RE: Application for Permit to Drill: Telonis 19-1038, Birkinshaw 18-1037, Telonis 16-1031,
Utah 33-1072, Utah 23-1026, Telonis 29-1060

**DIVISION OF OIL, GAS AND MINING
APPLICATION FOR PERMIT TO DRILL
STATEMENT OF BASIS**

OPERATOR: ConocoPhillips Company
WELL NAME & NUMBER: Telonis 29-1060
API NUMBER: 43-007-31152
LOCATION: 1/4,1/4 SENW Sec:29 TWP: 14 S RNG: 9 E 1886 FNL 2139 FWL

WELL TELONIS #29-1060
 Section 29, T14S, R9E, S.L.B.&M.
 Drawing L-1 4 of 4

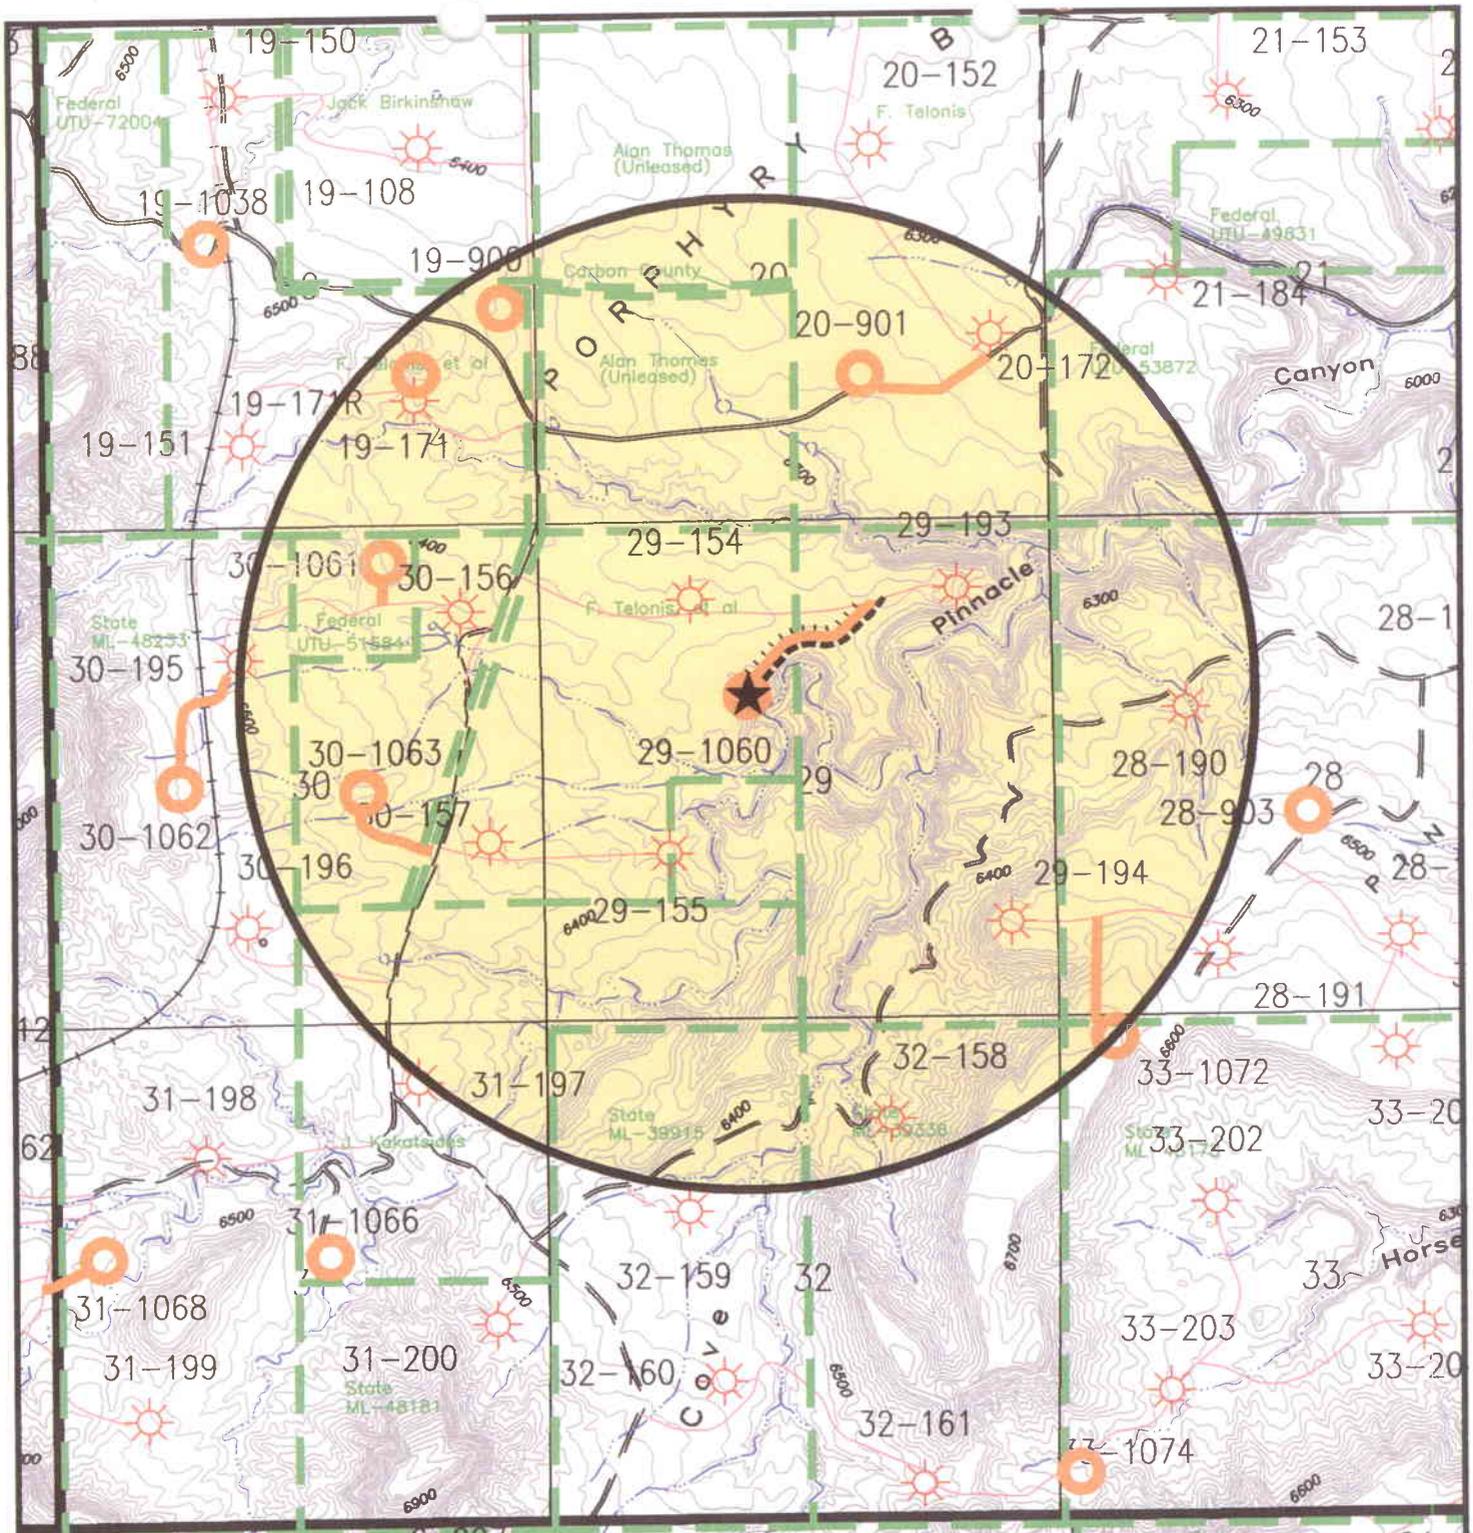
There is a shorter route that would disturb less of the surface, however the Landowner desired that the access road into this pad take the long approach that is shown.

Casing Schematic

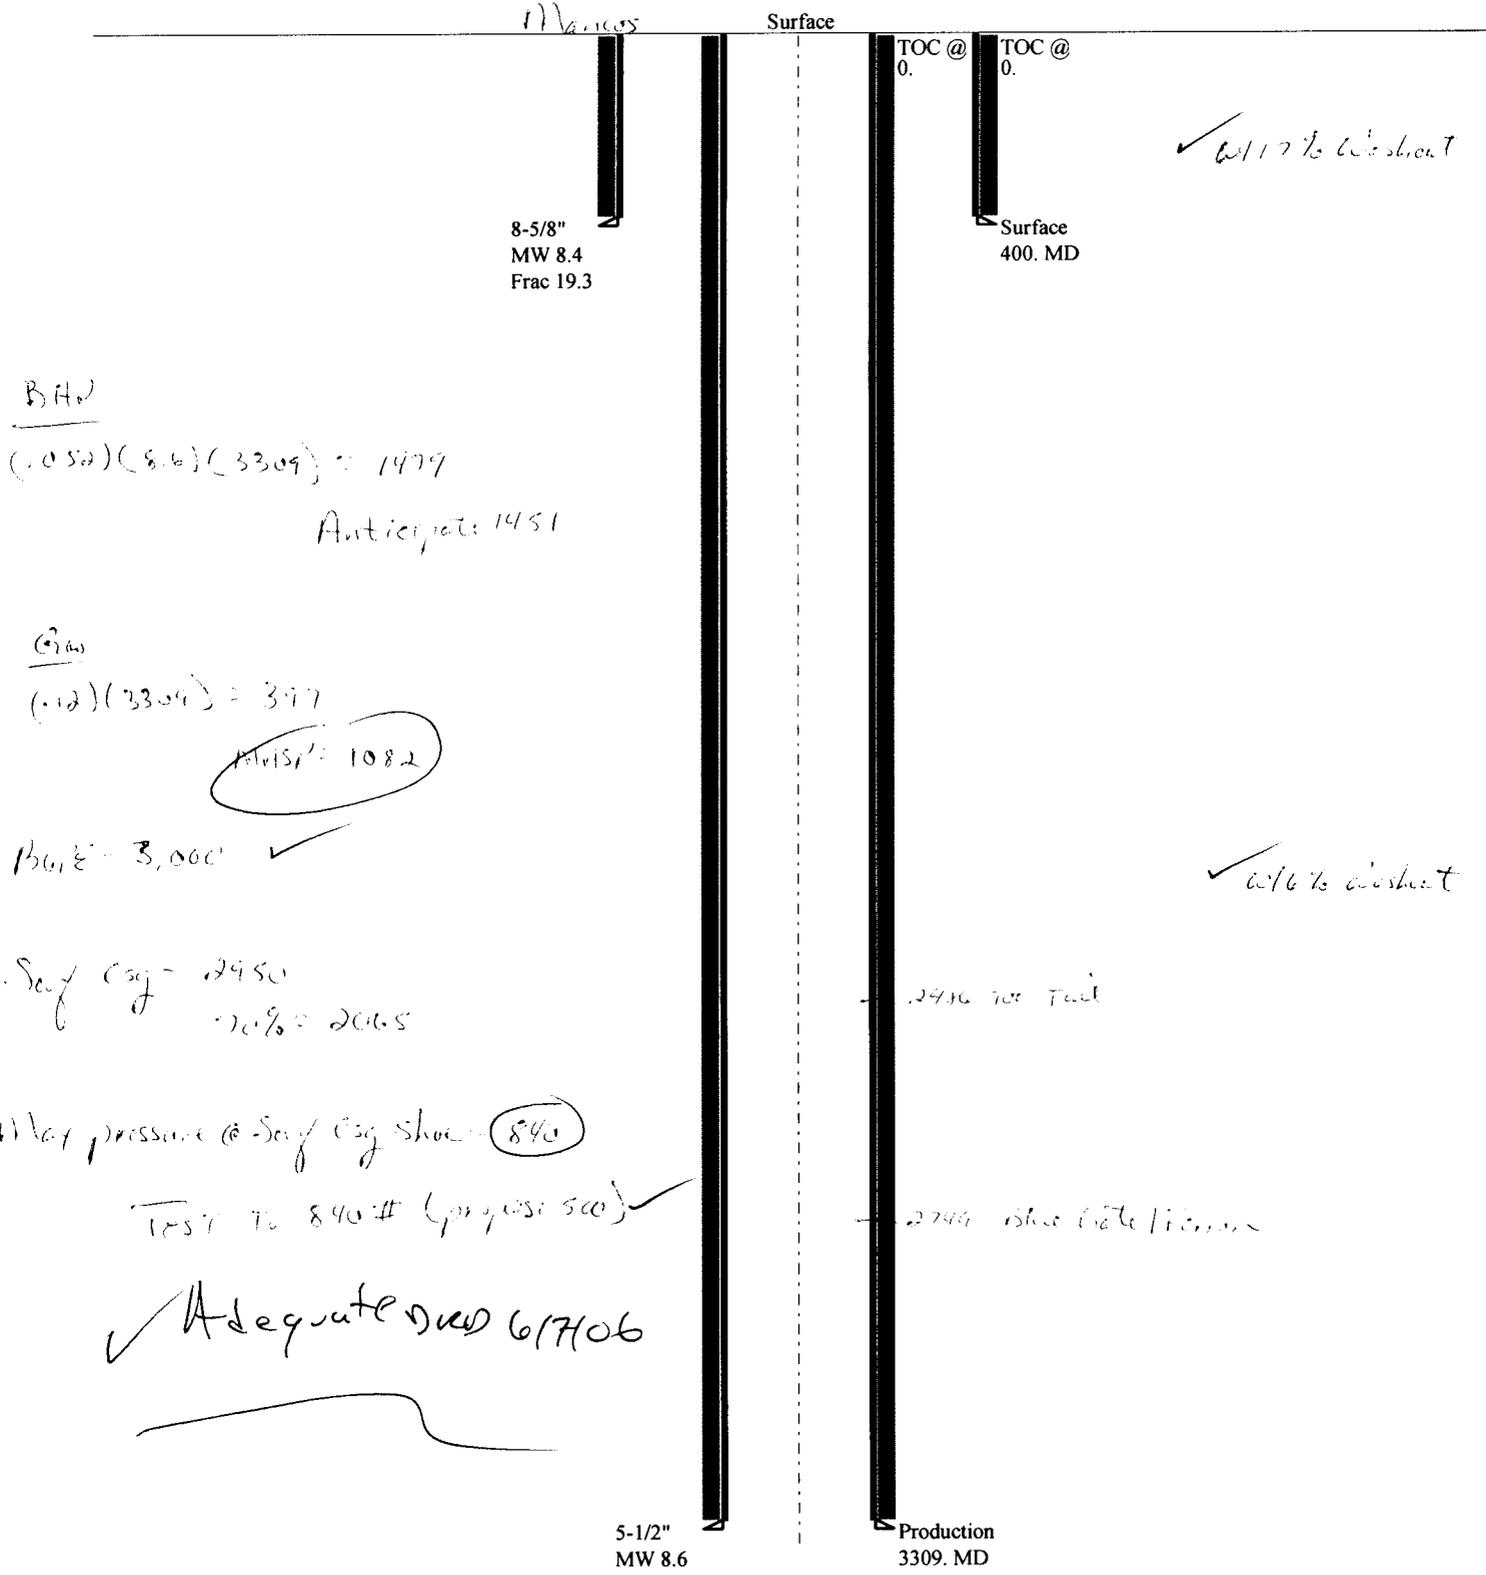
Mud weight: 8.400 ppg
Design is based on evacuated pipe.

Max anticipated surface pressure: 0 psi
Internal gradient: 0.447 psi/ft
Calculated BHP 179 psi

Next setting depth: 3,309 ft
Next mud weight: 8.600 ppg
Next setting BHP: 1,478 psi
Fracture mud wt: 19.250 ppg
Fracture depth: 400 ft
Injection pressure 400 psi

ENGINEERING STIPULATIONS: NONE
